SERVICE BULLETIN

ENGINE — GASKET, ASSEMBLY — INTRODUCTION OF A NEW GASKET ASSEMBLY TO MINIMIZE LEAKAGE

V2500 Series 72-0675

The purpose of this Service Bulletin is to introduce a new gasket assembly (#4 Chevron Seal) to minimize diffuser case leakage.

LOCATION OF THE GASKET ASSEMBLY FIGURE 1

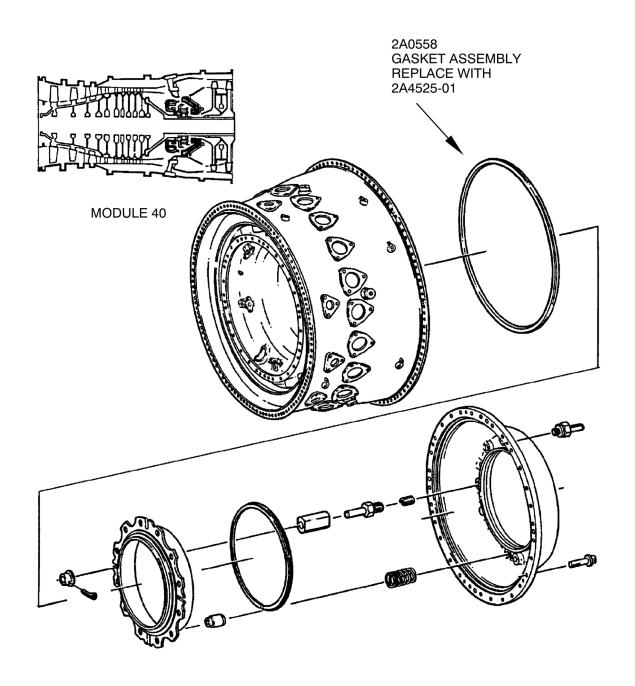
- 1. Replace the Gasket Assembly, PN 2A0558 with PN 2A4525-01. See Figure 1 and Figure 2.
- 2. Recording Instructions
 - A. A record of accomplishment is required.
